DCD Section 6.3 Clarification Call (June 7, 2016) NPSH Audit Notes and Questions

1. Page 24 of Technical Report APR1400-E-N-NR-14001-P, Rev. 0, indicates a value of 2.95 ft. for the $NPSH_m$. Table 3.6-2 indicates a value of 1.73 ft. for $NPSH_m$. Please explain the discrepancies.

Figure 3.9-3 Schematic Diagram for IRWST Water Volume

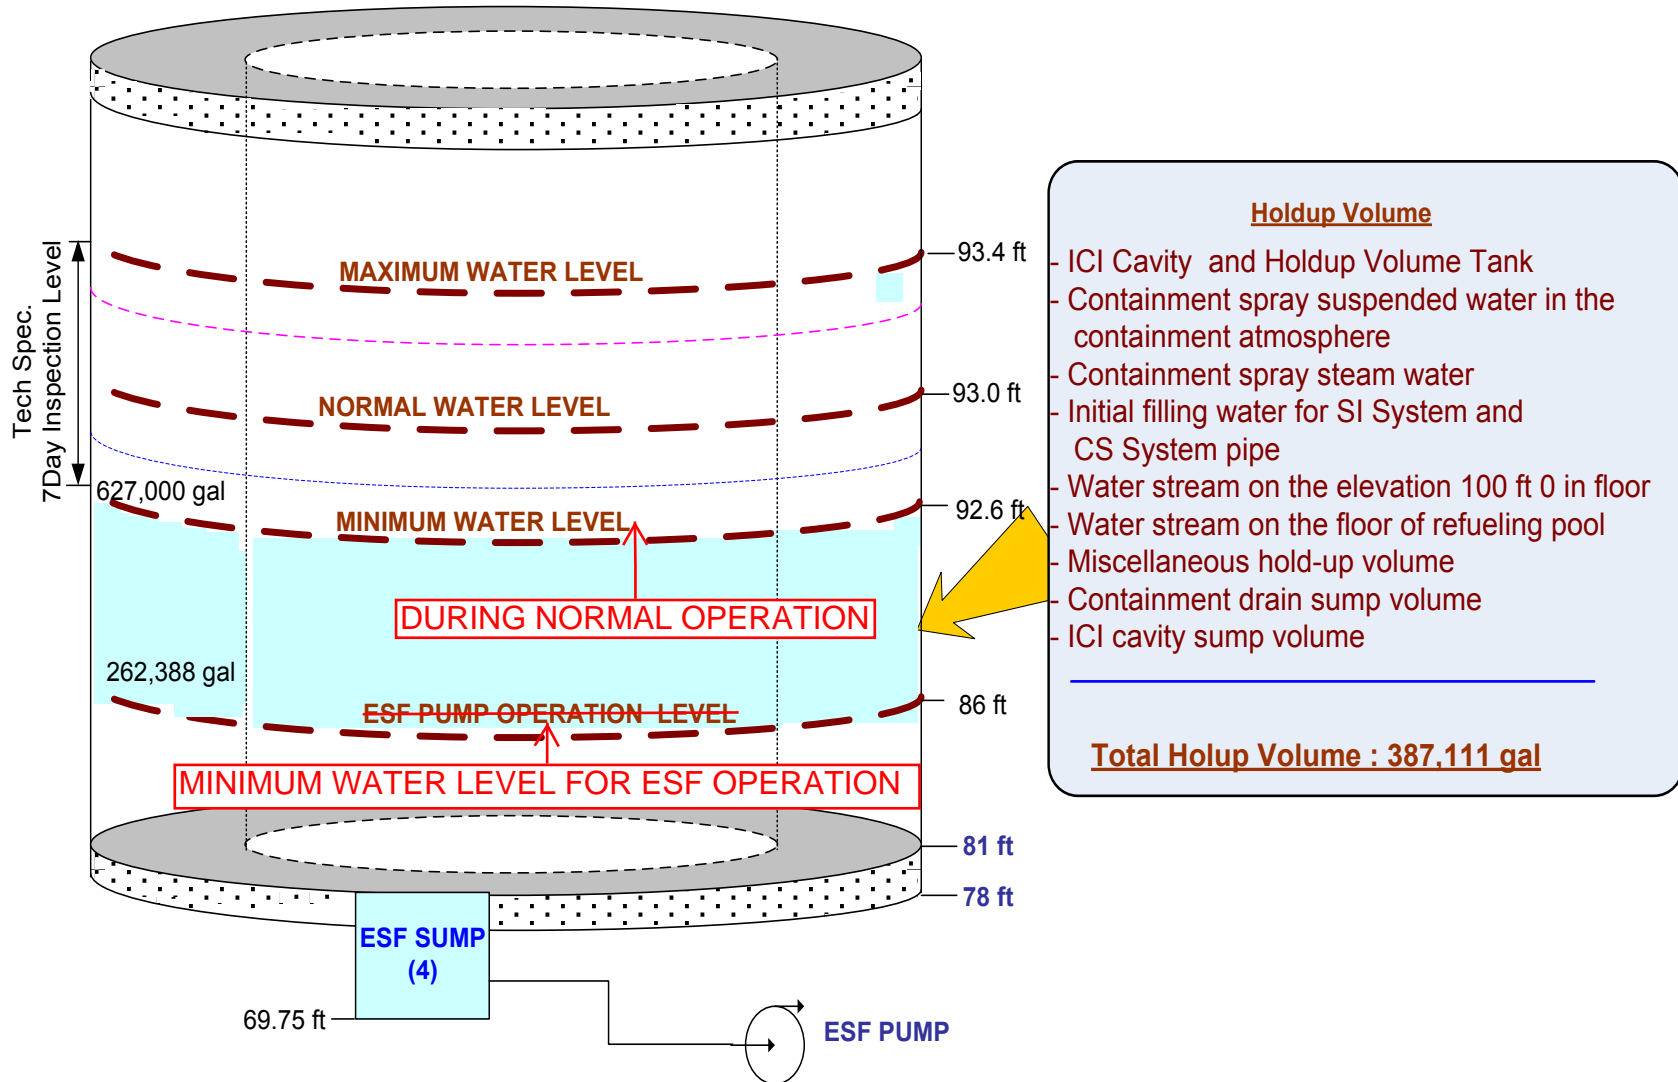
3. Figure 3.9-3 of APR1400-E-N-NR-14001-P – clarify the values used to calculate 262,388 gallons.

Response

During normal operation, the IRWST water level is maintained at 93.0 ft. (elevation, EL) (77.04%, 649,000 gal). The IRWST is designed to minimize water evaporation, however, if the IRWST water level is less than 92.6 ft. (EL) (74.43%, 627,000 gal), the water level is recovered by a makeup operation from the boric acid storage tank via the boric acid makeup pump. Therefore, the water level of 92.6 ft. (EL) is the minimum IRWST water level during normal operation and becomes the initial water level for postulated accidents.

The calculated IRWST water level for ESF operation during a LOCA is calculated by subtracting the holdup volume and inactive pool volume from the initial water volume at 92.6 ft. (EL) followed by adding the volume of three SITs, as follows:

$$V_{ESF, \text{ calculated}} = V_{Initial} - V_{Holdup} - V_{Inactive} + V_{SIT} = 280,056 \text{ gallon}$$

- $V_{ESF, \text{ calculated}}$ = calculated IRWST water volume for ESF operation
- $V_{Initial}$ = Initial water volume, 627,000 gallon
- V_{Holdup} = Holdup volume on the way to the IRWST, 162,829 gallon
- $V_{Inactive}$ = Inactive pool volume, 224,282 gallon
- V_{SIT} = Volume of three SITs, 40,167 gallon

$$H_{cal} = \frac{V_{ESF}}{\pi (R_{outer}^2 - R_{inner}^2)} = 5.07 \text{ ft}$$

- H_{cal} = Calculated equivalent IRWST water height for ESF operation
- R_{outer} = IRWST outer radius, 71.83 ft.
- R_{inner} = IRWST inner radius, 53 ft.

Since the instrument lower tap height of 0.25 ft. is considered above the IRWST floor of 81 ft. (EL), the actual IRWST water level for ESF operation from the IRWST floor becomes 86.32 ft. (EL) (81 + 5.07 + 0.25 ft.).

The design basis of the minimum IRWST water level for ESF operation is set at 5 ft. above the IRWST floor, or 86 ft. (EL), with a margin of 0.32 ft.

Therefore, the water volume at 86 ft. (EL) of the IRWST water level becomes the minimum water volume for ESF pumps operation. The V_{ESF} volume of 262,388 gal is calculated as follows.

$$\begin{aligned} V_{ESF} &= \pi (IRWST \text{ outer radius}^2 - IRWST \text{ inner radius}^2) \\ &\quad \times (Minimum \text{ water level for ESF operation} - IRWST \text{ lower tap level}) \\ &= \pi (71.83 \text{ ft}^2 - 53 \text{ ft}^2) \times (86 \text{ ft} - 81.25 \text{ ft}) = 262,388 \text{ gal} \end{aligned}$$

In order to clarify these points, DCD, Subsections 6.2.1.1.2.2 and 6.8.4.5.8, and TeR, Subsections 3.6.2, 3.9.1, 3.9.2, and Figure 3.9.3 will be revised as shown in Attachment 2 and 3.

The minimum water level of the IRWST during a LOCA is calculated by subtracting the holdup volume from the initial water volume in the IRWST and by adding the volume in three SITs. The minimum water level  used in the NPSH evaluation is calculated as 1.52 m (5 ft) above the IRWST bottom (El. 81 ft) and is shown in Figure 3.9-3.
